BUILDING SCOPE ADDENDUM NO. 01

This Addendum is a summary of clarifications, interpretations, corrections and/or modifications to the Contract Documents for the Conestoga High School Athletic Fields Project prepared by Heckendorn Shiles Architects.

1 FIELD HOUSE - LIGHTING
E101 1/8" = 1'-0"

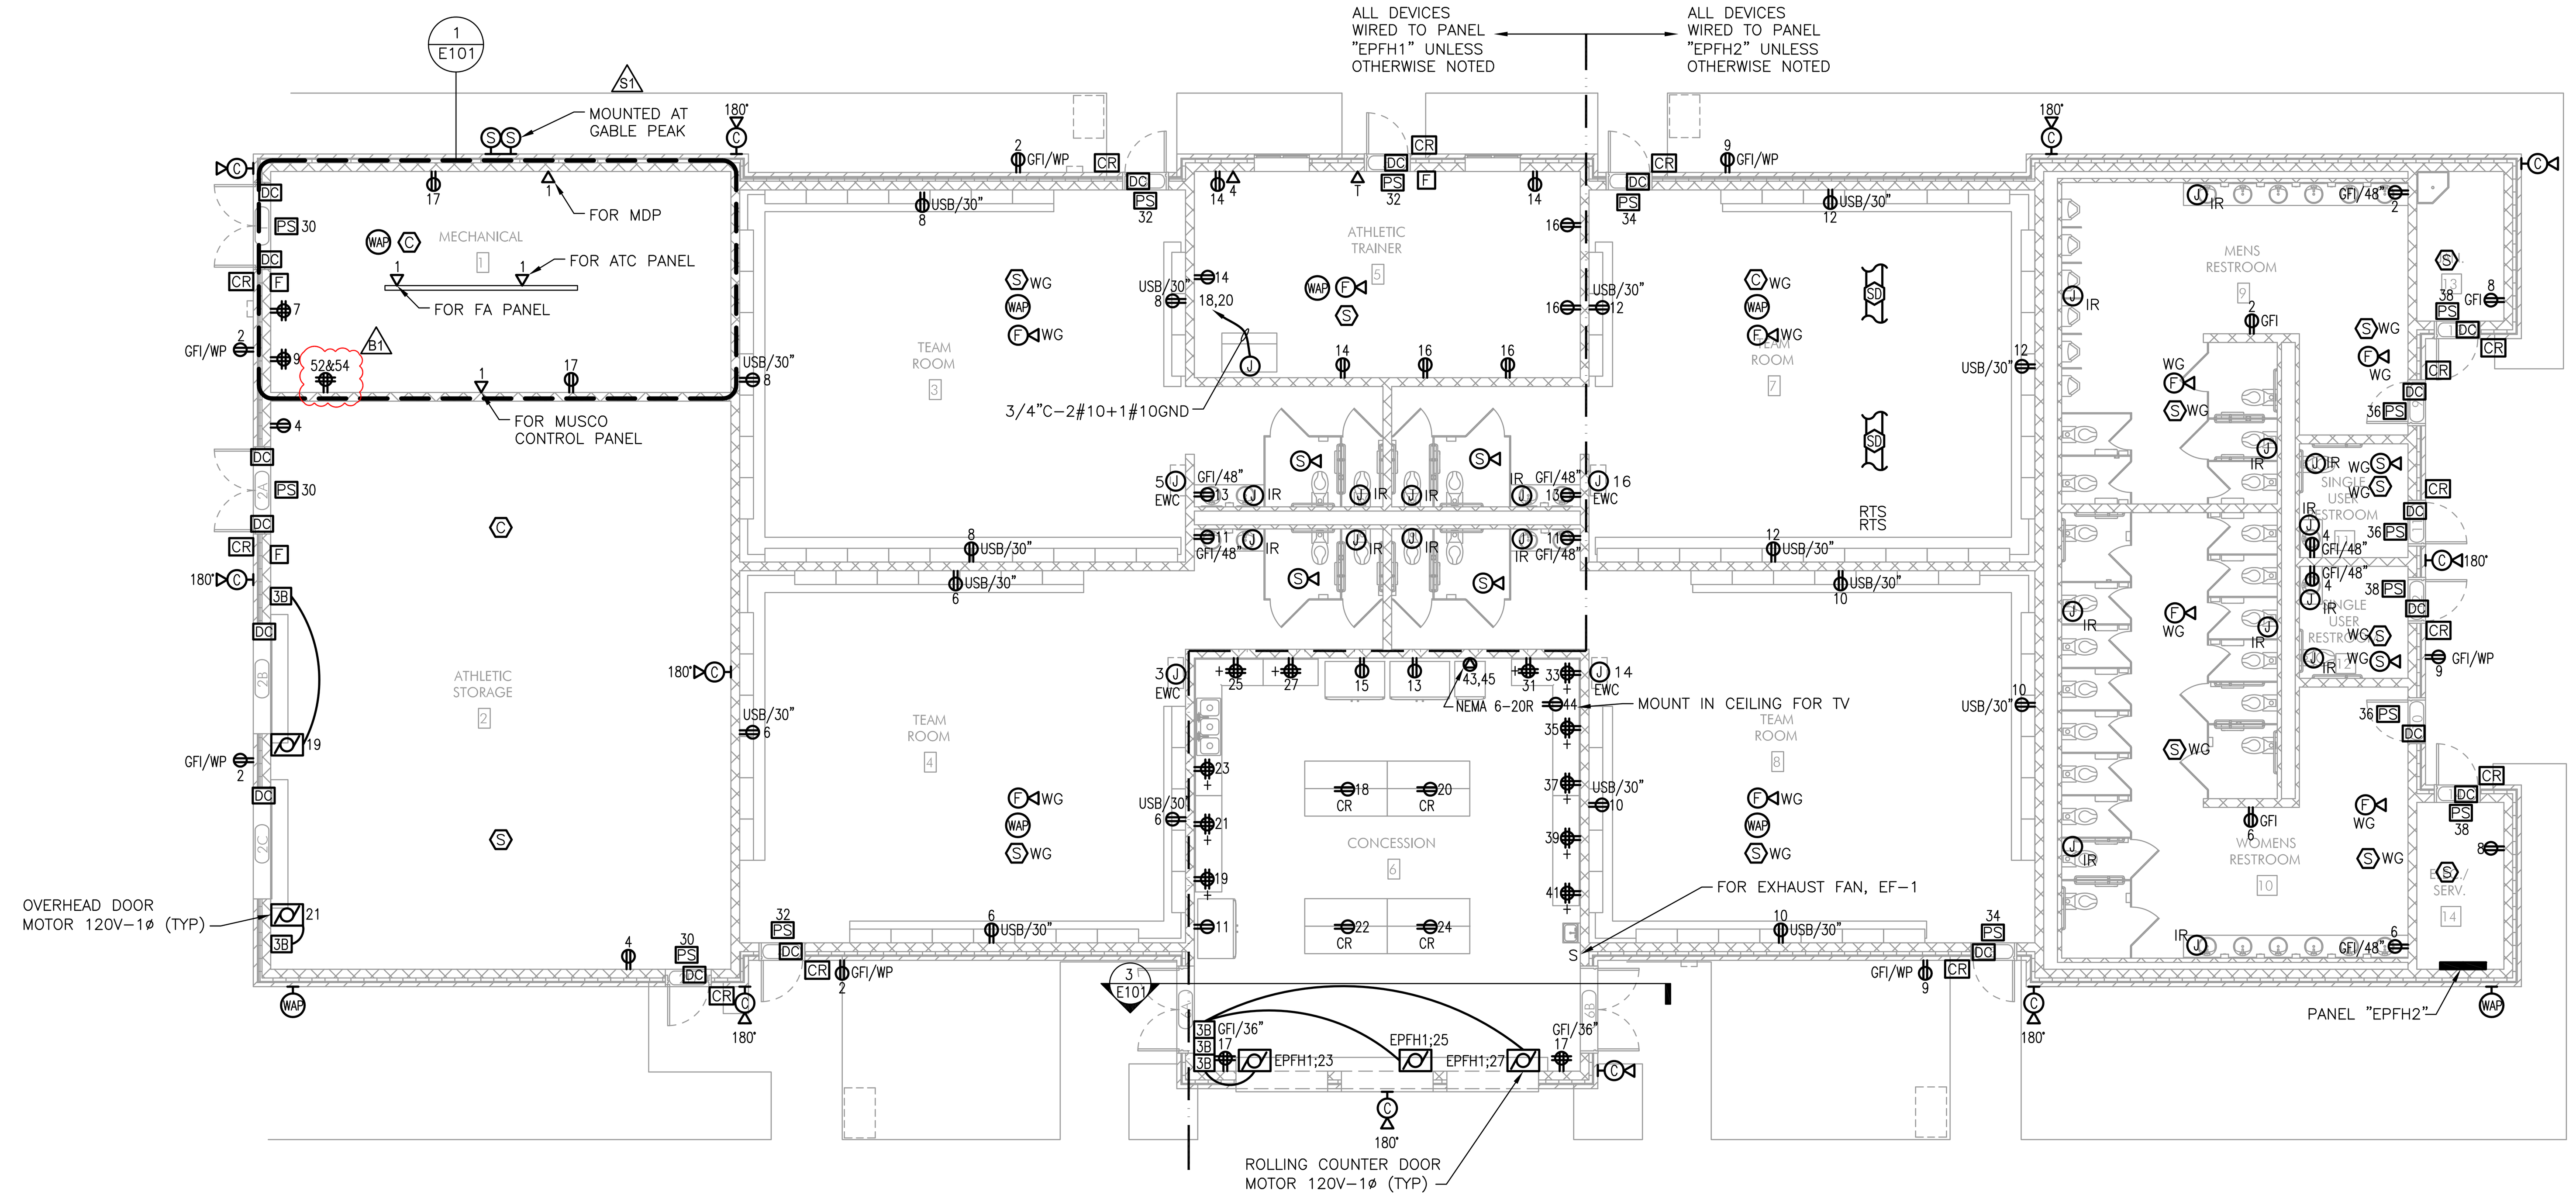
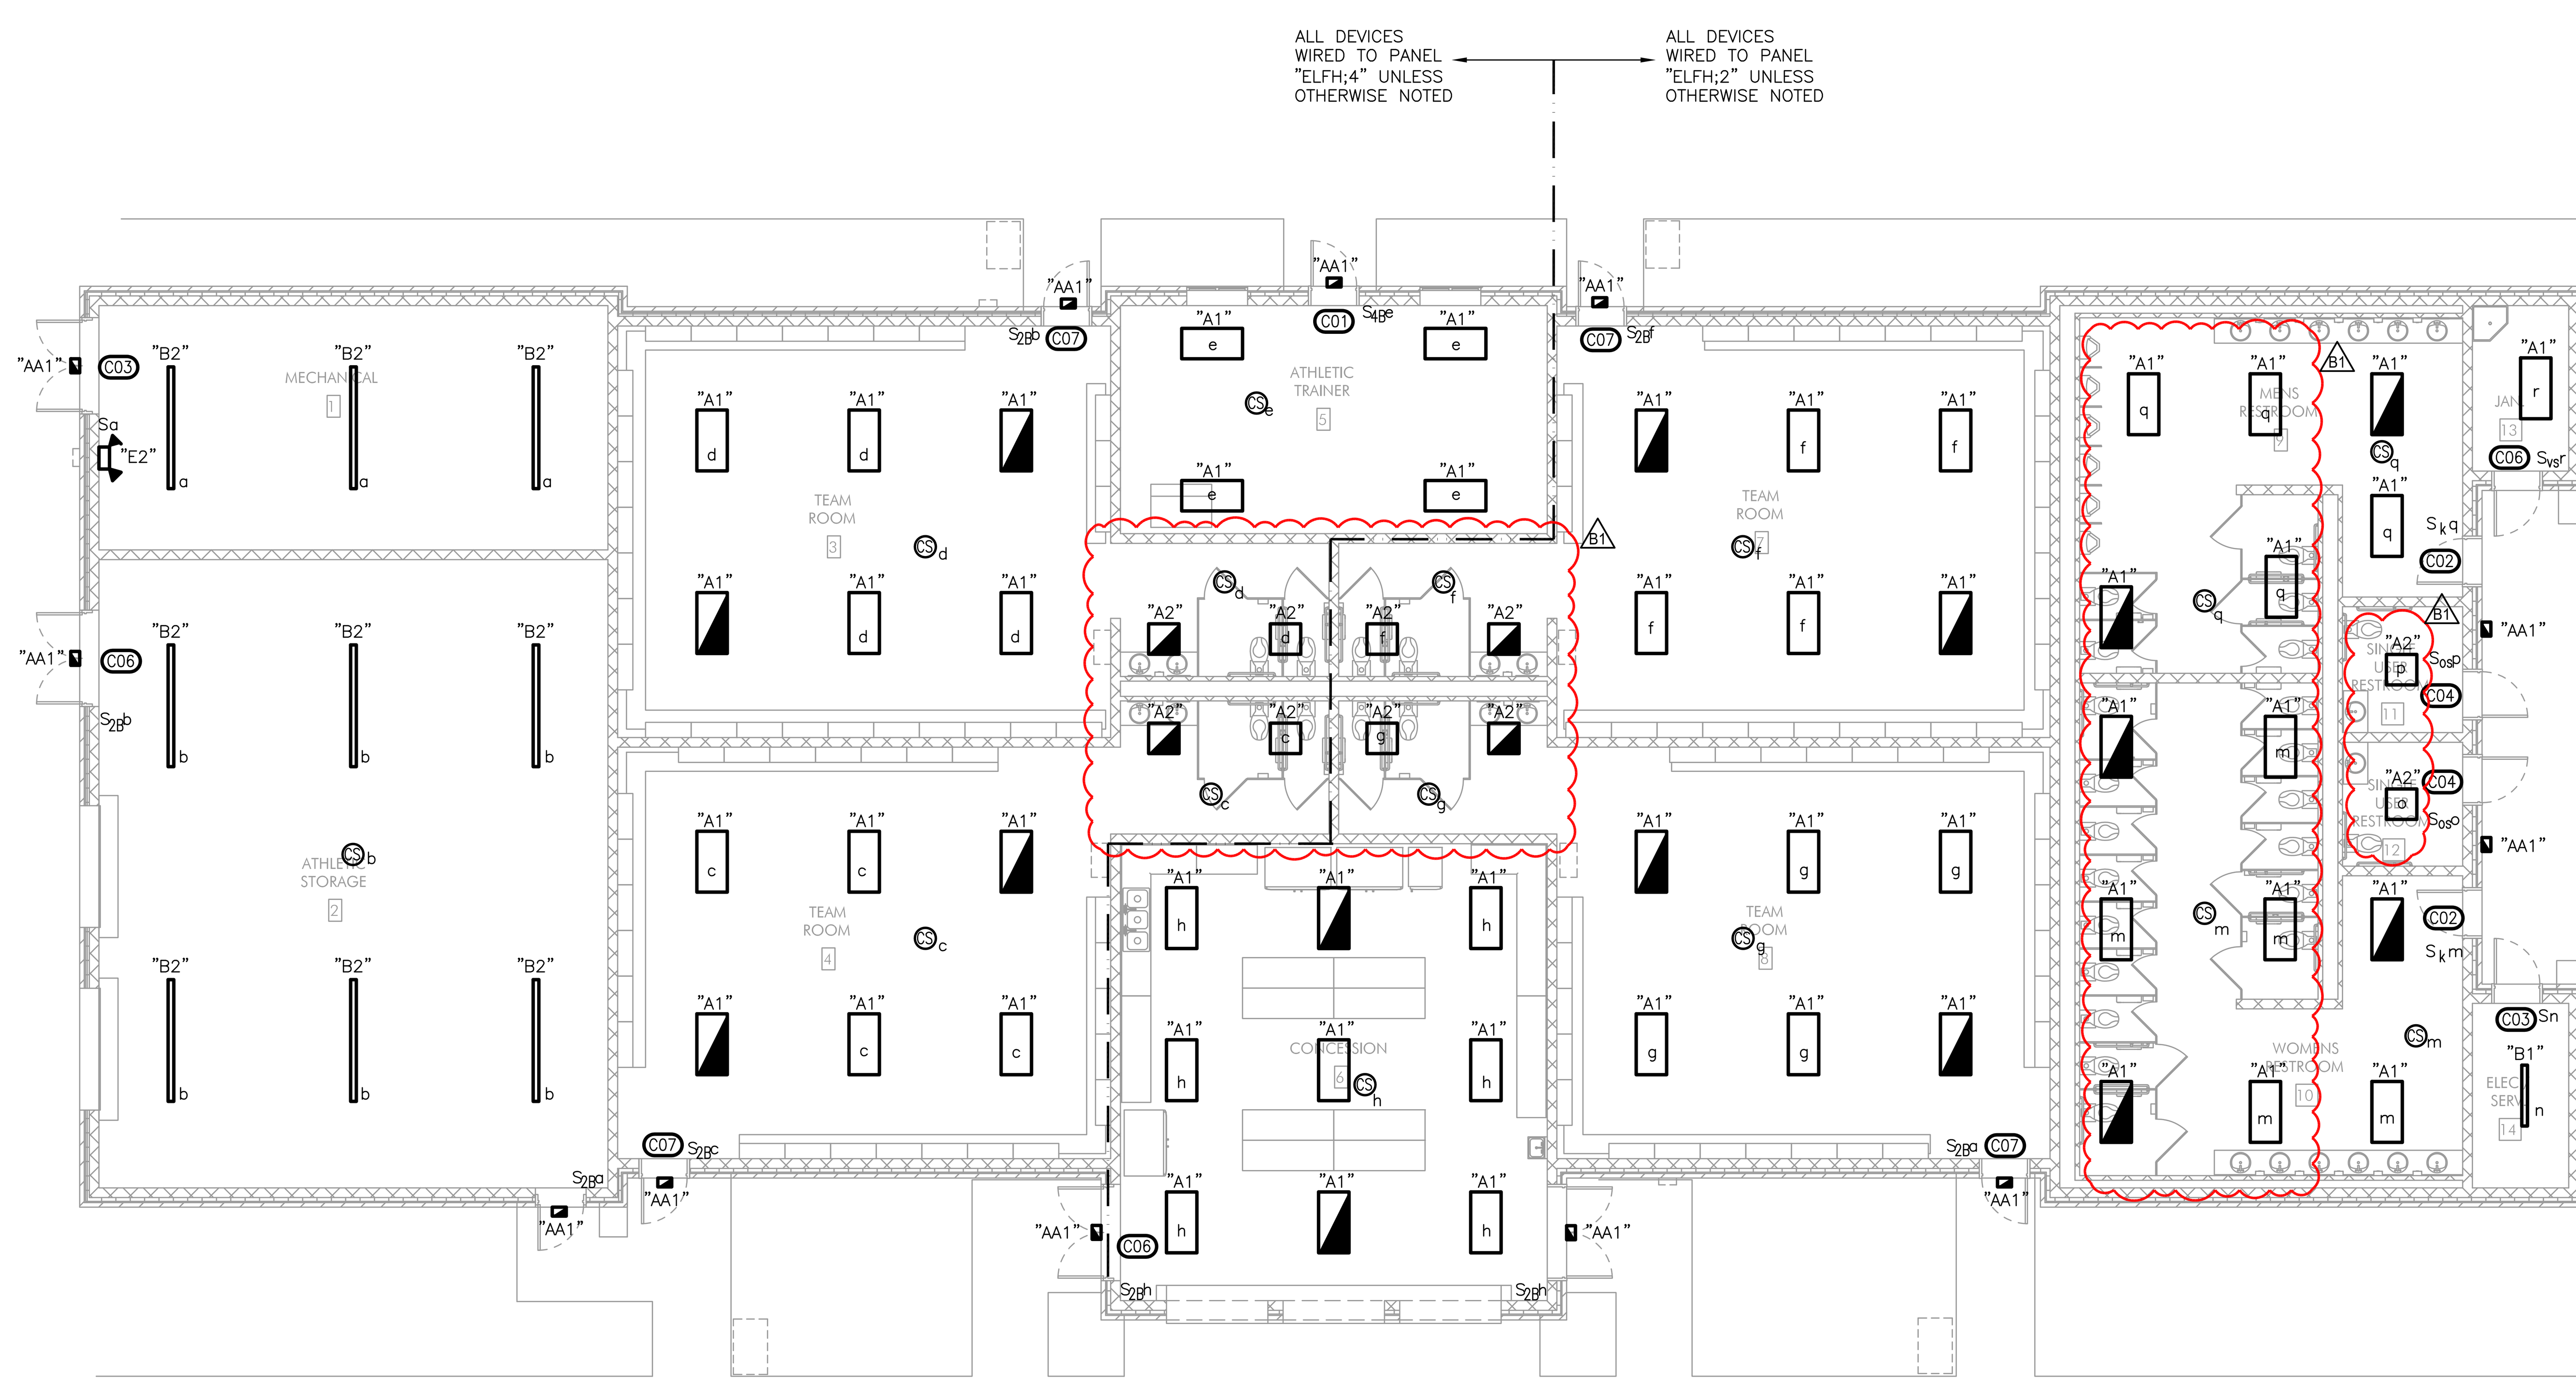
48. Question: Refer to Drawing #E101, at "LIGHTING" portion. No Exit Signs are shown. Please show Types and locations accordingly.

1. Specification - 281600 Intrusion Detection - Remove this section in its entirety.
2. Drawing – E001 Updated symbols and Contractor Responsibiliy Matrix
3. Drawing – E101 Added receptacle for AV Rack and shifted lights.
4. Drawing – E302 Added circuits for AV Rack and added additional spare breakers.

Response: Exit signs are not required.
